No. 265

New Version of High Security Escutcheon

PRODUCT UPDATE

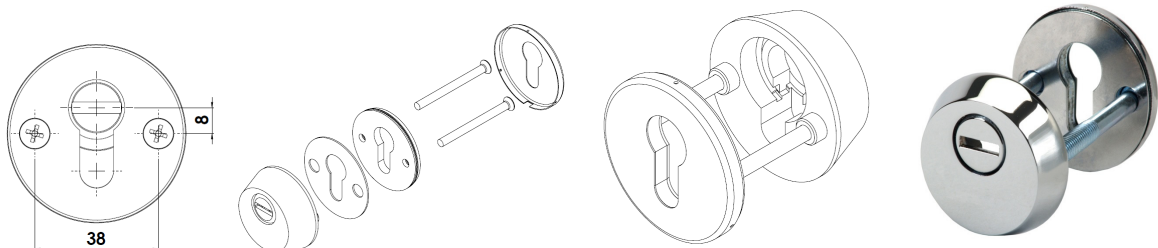
The new version of cylinder protectors is now made of HARDENED STEEL, both body and rotating disk, providing enhanced drilling protection.

Esthetic design was treated as well by eliminating exposed screw (from the interior side) with a nice coated cover

Please note, due to the change of material there might be slight difference between the new and the previous finish colors.
